SUBJECT: NUCLEAR REGULATORY COMMISSION REPORT FOR THE AUDIT OF DUKE ENERGY PROGRESS FLOOD HAZARD REEVALUATION REPORT SUBMITTAL RELATED TO THE NEAR-TERM TASK FORCE RECOMMENDATION 2.1-FLOODING FOR BRUNSWICK STEAM ELECTRIC PLANT, UNITS 1 AND 2 (CAC NOS. MF6104 AND MF6105; EPID L-2015-JLD-007 AND EPID L-2015-JLD-008)

**NUCLEAR REGULATORY COMMISSION REPORT FOR THE AUDIT OF DUKE ENERGY  
PROGRESS, LLC's FLOOD HAZARD REEVALUATION REPORT SUBMITTAL RELATED TO  
THE NEAR-TERM TASK FORCE RECOMMENDATION 2.1-FLOODING FOR BRUNSWICK  
STEAM ELECTRIC PLANT, UNITS 1 AND 2 (CAC NOS. MF6104 AND MF6105)**

**ATTACHMENT 2  
Brunswick Steam Electric Plant, Units 1 and 2 Information Needs and Response Summary**

Information Needs 16 and 19 – Figure 1: Screen capture from PMHscreeningRuns11.xls with runs sorted by water level at the site

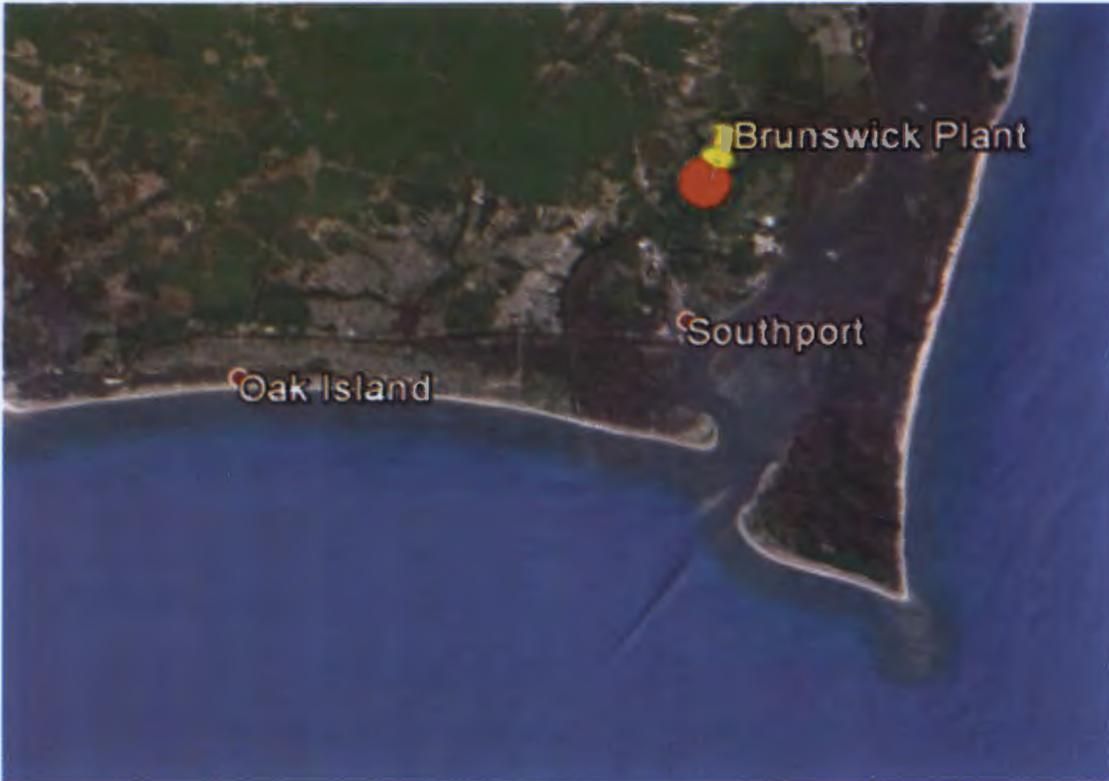
16	SSA 4 12/22/15	<p><b><u>Storm Surge Analysis</u></b></p> <p><u>Background:</u> The FHRR (Duke Energy, 2015) (Section 4d, page 46) states that the worst case PMH scenario was developed from 79 different PMH scenarios. The FHRR stated the worst case PMH featured a “a maximum wind speed of 145 knots, radius of 30 mi, forward speed of 30 miles/hour (mi/h), bearing of 310 degrees, landfall point 18.6 mi west of Cape Fear River mouth, and minimum central pressure of 12.96 pounds per square inch, (psi).” The 310 degree bearing equates to a storm heading 50 degrees west of north (FHRR Figure 4-18). The FHRR does not contain details of the results for the 79 screening runs or if other storms produced maximum storm surge near Brunswick that nearly equaled the worst case storm (Duke Energy, 2015).</p>	<p>In response to this information need the licensee stated that (Duke Energy, 2016):</p> <p>The ranges for the different values associated with storm characteristics included in the screening analysis were selected based on the guidance in the NOAA Technical Report 23 (TR23) (NOAA, 1979), as described on sheet 21 of 43 in the BNP-MECH-FHR-006 Storm Surge Analysis Calculation (AMEC, 2015f) package. In particular, limits of storm track directions for the PMH event are presented as a function of coastal distance and storm category in Figure 3-9 (sheet 22 of 43 of the same calculation package, equivalent to Figure 2.9 in the NOAA TR23). The PMH Screening Process is further described in Section 4.2 (sheet 32 of 43) in the BNP-MECH-FHR-006 Storm Surge Analysis Calculation (AMEC, 2015f) package. The stillwater level equivalent to present-day MSL was used in all screening simulations. Based on the</p>

Information Need No.	Reference Number/ Transmittal Date <sup>1</sup>	Information Need Description	Response
		<p>As part of the audit material reviewed for Brunswick (FHRR calculations and reports), the staff looked at additional details on the 79 screening storms. Review of the results for the 79 screening runs at licensee-selected locations near the site (PMHscreeningRuns11.xls in the folder: BNP-14-006_Storm_Surge &amp; BNP-14-009_Combined_Effects\01 Data Package\PMH_Screening_Results) indicated that storms with more northerly tracks (bearings 350 or 10) produced significantly higher surge at Southport (less than 4 mi south of the site) than the maximum surge values listed in the tables for the PMH worst case scenario storm. The storms with more northerly tracks that produce high water levels near Southport, feature reduced water levels (more than 2 ft.) at the site. Independent ADCIRC simulations conducted by NRC staff found that that some storms with northerly tracks can feature higher surge levels at Brunswick than at Southport. From the NRC independent ADCIRC simulations, the top surges at Brunswick resulted from storms that featured tracks with storms heading north or east of north.</p> <p><u>Request:</u> Please provide additional discussion on the physical explanation for how the more northerly storms that feature high water levels at Southport do not result in worst case water levels at Brunswick (see Figures 1 and 2 in Attachment 3; Figure 1: Screen capture from PMHscreeningRuns11.xls with runs sorted by water level at the site; and Figure 2: Screen capture from PMHscreeningRuns11.xls with runs sorted by water level at Southport)</p>	<p>NOAA TR23 (NOAA, 1979) guidance, the plausible limits of storm track directions at landfall were considered within the range of 270 degrees to 10 degrees to true north, and screening runs were subsequently focused on discrete direction bins from 290 degrees to 10 degrees. Therefore, the direction of 30 degrees was not considered as a plausible storm track direction for candidate PMH events as per TR23 (NOAA, 1979).</p> <p>The results from the screening runs indicated a sensitivity to direction at landfall. However, it is noted that the results are simultaneously sensitive to the values of the forward speed and landfall location as well. The simulated surge levels induced by PMH candidate storms near the site are the result of several forcing factors that interact with each other in a complex coastal environment. It is not unexpected that peak water levels would vary spatially and temporally, particularly when comparing water levels at Southport and those in the inflow channel or Nancy's Creek near the site.</p> <p>The licensee provided their response/method for this specific information need. However, the response did not close the Item as the response did not adequately explain the Delft3D model features. Therefore, the NRC staff issued a follow-up information need (Information Need #19).</p>

Information Need No. 19 – Figure 3: Area 1 approximate boundary

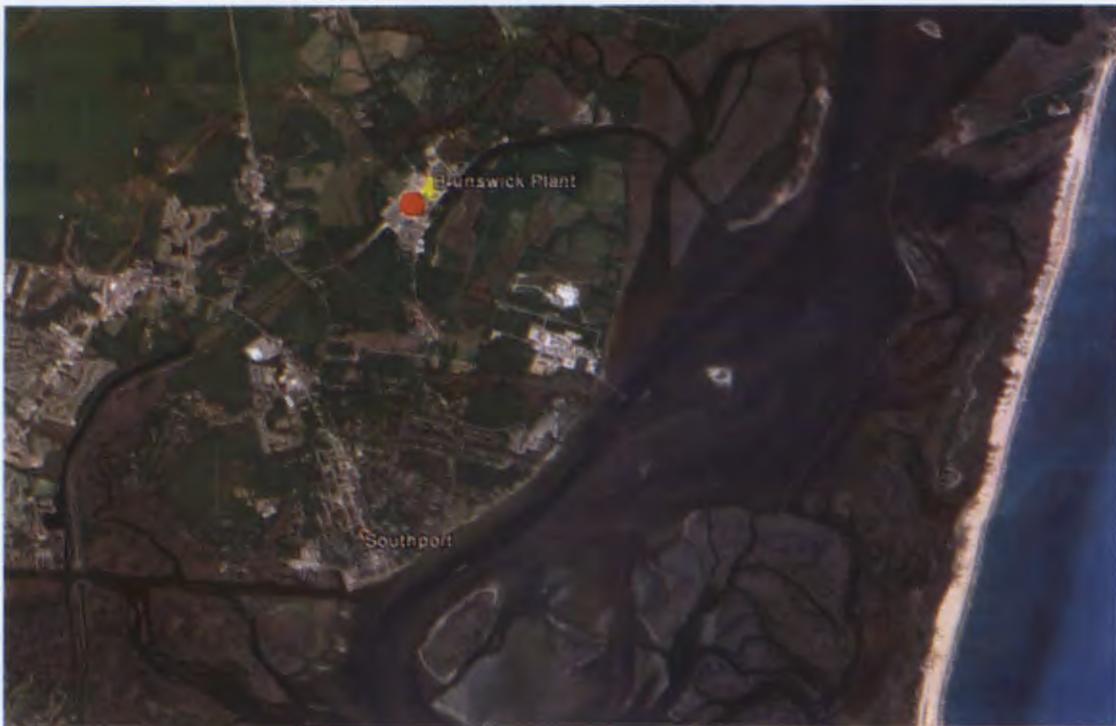
Information Need No.	Reference Number/ Transmittal Date <sup>1</sup>	Information Need Description	Response
		<ul style="list-style-type: none"> <li>• For each of the two approximate areas shown in Figures 3 and 4 (Area 1, Area 2) shown in Attachment 3 please provide a series of figures or an animation of water levels for the storms listed in Table 1. The products provided (series of figures or animations) should include temporal resolution to show how the storm surge propagates northward from the ocean past Southport and to the site.</li> <li>• Provide figures that show the Delft3d model bathymetry and topography for Area 1 and Area 2 with a contour interval for Area 2 that allows examination of features that will alter storm surge between Southport and the site.</li> <li>• Provide figures that show the Delft3d model land use and/or bottom friction coefficient for Area 2 with a contour interval that allows examination of features that will alter storm surge between Southport and the site.</li> </ul>

Information Needs No. 22 – Figure of Transects

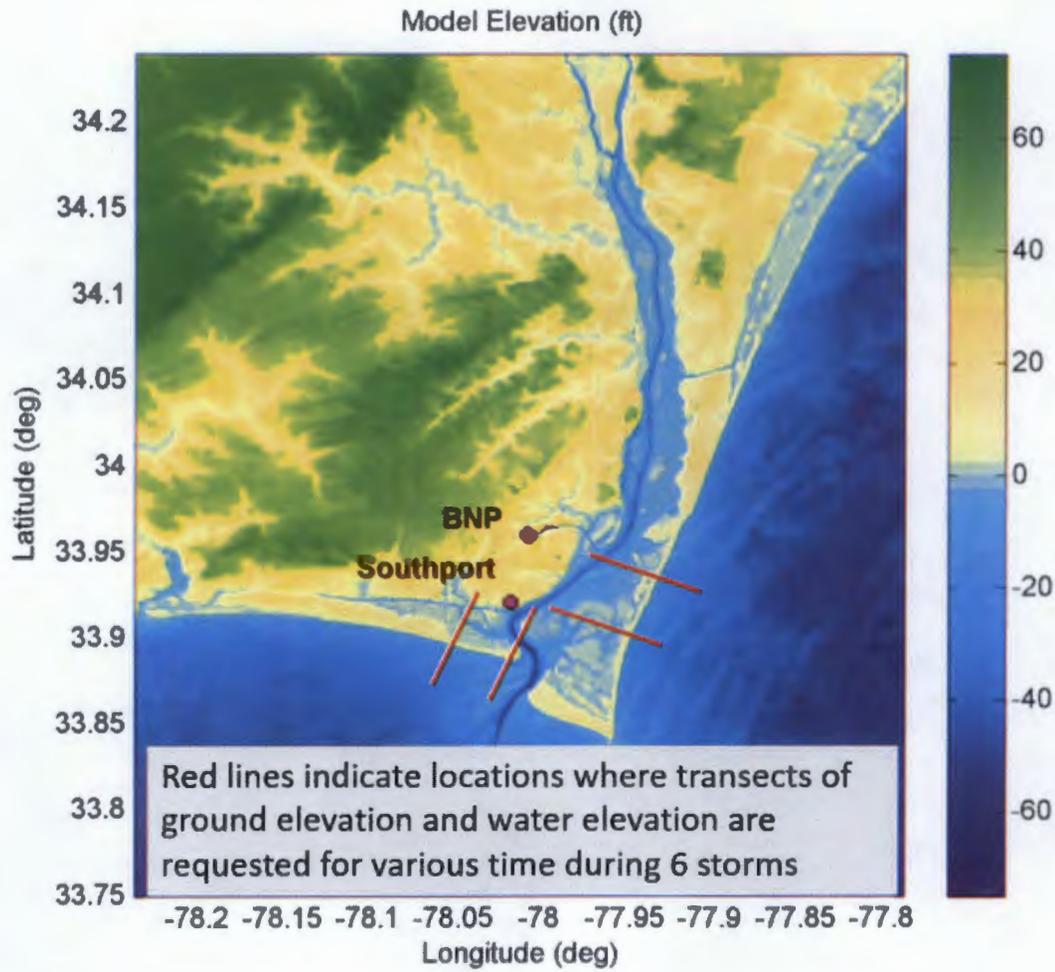
Information Need No.	Reference Number/ Transmittal Date <sup>1</sup>	Information Need Description	Response
22	SSA 4b 3/16/16	<p><b><u>Supplemental Request for Storm Surge Analysis</u></b></p> <p><u>Background:</u> After analyzing the licensee's responses to the information needs on the storm surge analysis and the discussion held during the March 10, 2016, audit, the NRC staff determined the need for additional supplemental information. This additional information will support the evaluation of the licensee's methodology and results of the reevaluated storm surge flooding mechanism at Brunswick.</p> <p><u>Request:</u></p> <ol style="list-style-type: none"> <li>1. The license should provide plots that show the maximum water level (over the entire storm) for the 6 storms included in our original Information need request. Figure extents that match the licensee's Area 0, 1, and 2 (licensee ground elevation plots) would allow comparison between storms and locations.</li> <li>2. To understand the features water level gradients inside/outside the barrier islands observed (and discussed) during the audit, the licensee is requested to provide ground elevation and water levels along the transects shown in the figure below [see Attachment 3). The water level data should occur at times before, during, and after peak water levels inside and outside of the barrier islands.</li> </ol>	<p>In response to this information need the licensee uploaded documentation (Duke Energy, 2016) that listed for each of the six storm events the time of maximum water level and a tabular reference for page numbers corresponding to the profile set for each of the four transects. The licensee also uploaded plots of water level and ground elevation at 10-minute time steps along each of the four identified transects and for each of the six storm events.</p> <p>The licensee's response and products (figures/transects) provide most of the materials requested in this revised information need request. However, the maximum water level plots for the 6 storms were not provided.</p> <p>After review of the transect plots, NRC staff had unresolved questions concerning the model results within the products provided and therefore, issued a supplemental information need request (See Information Need # 23).</p>
